**Re: Item - 2026.TE32.9
Statutory Public Meeting
390 - 398 Spadina Road - Zoning By-law Amendment Application
Request for Deferral – Revisions to the Proposal**

**Re: Application to Redevelop 390 – 398 Spadina Road
Comments and Concerns**

Section A: Diagram of front yard set-backs, step-backs and rear yard transition.

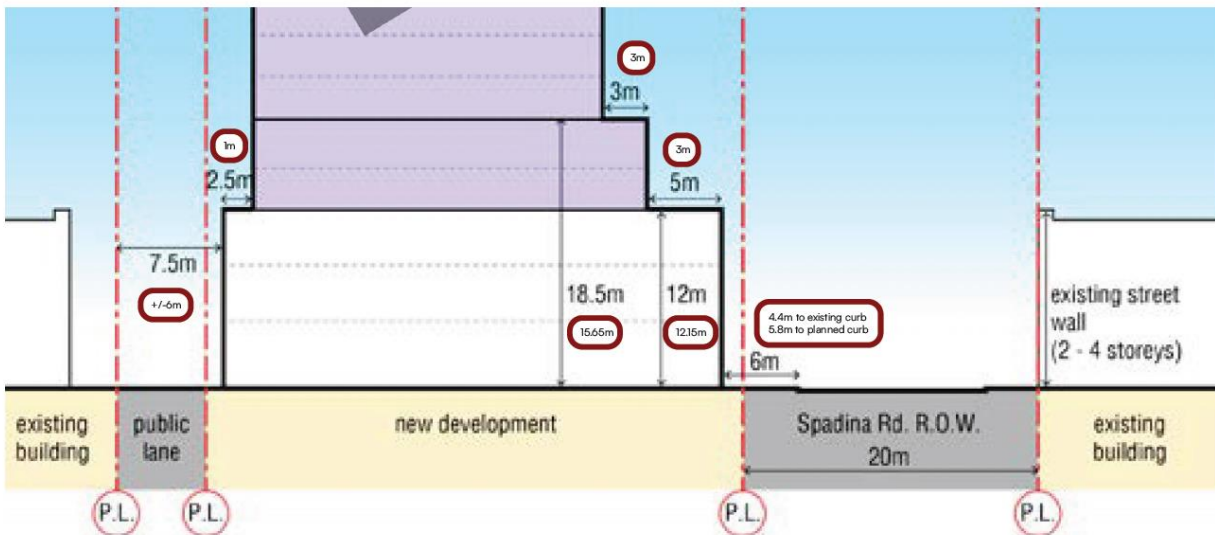
Regrettably, as currently formulated, the proposed redevelopment falls short of both guidelines in several ways. At first instance, it is important to note that the proposed redevelopment fails to meet the setbacks and stepbacks in the FH Guidelines. The deficiencies are shown in the sketch below, in which the dimensions of the proposal are shown in bubbles as against the FH Guideline setbacks and stepbacks:

1. As discussed in detail above, the **setbacks and stepbacks** in the FH Guidelines have not been implemented, contrary to the statement at page 9 of the Staff Report. Implementing these setbacks and stepbacks is important to reinforce the existing scale and street enclosure, while mitigating pedestrian perception of additional density.
